138196/LO/2023

Condition 7 - Prior to any entrance lobby fit out works taking place, the council requires the applicant to investigate whether the existing lobby bulkhead above the entrance can be removed and submit final drawings reflecting any associated works.

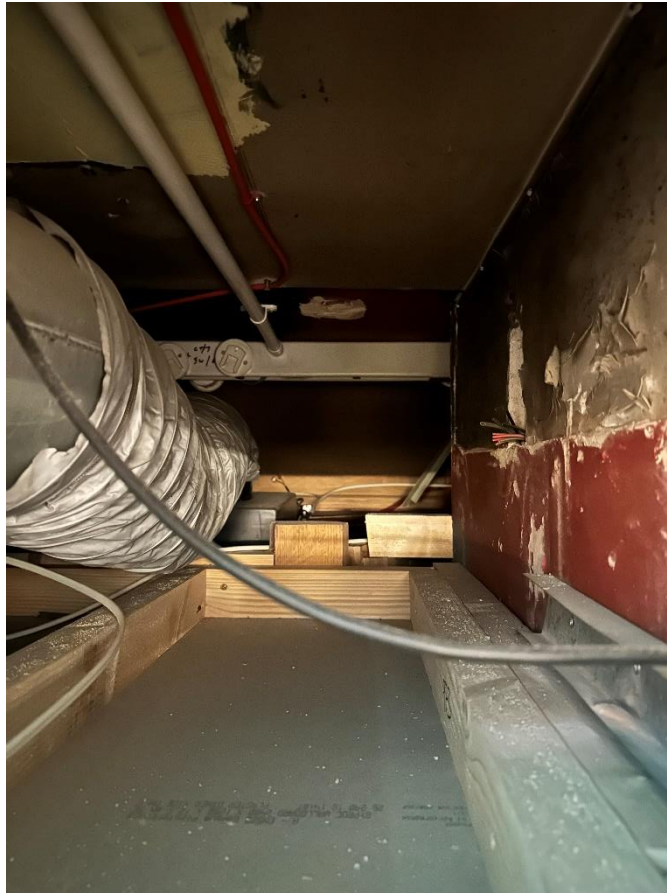
- APM to Manchester City Council (MCC) – 16/05/2024
 - IMG 5982,5983 & 5984 – Taken above ground floor entrance bulkhead – as you can see there appears to be very little of heritage note above the lobby bulkhead unfortunately.

- MCC to APM – 21/05/2024
 - Shopfront Bulkhead – The provided photos show that the bulkhead doesn't conceal anything of historic value. Please can you provide some brief comments on the proposed works you wish to undertake to it prior to works commencing so the Council can give informal sign off. Please note formal discharging of the condition will still be required.

- APM to MCC – 03/06/2024
 - We intend to cover the bulkhead back in , given the number of services contained & to avoid the need to add any additional service access hatches.

- MCC to APM – 12/06/2024
 - Bulkhead – This approach is acceptable. A discharge of conditions app formally setting this approach out will be required for condition 7.
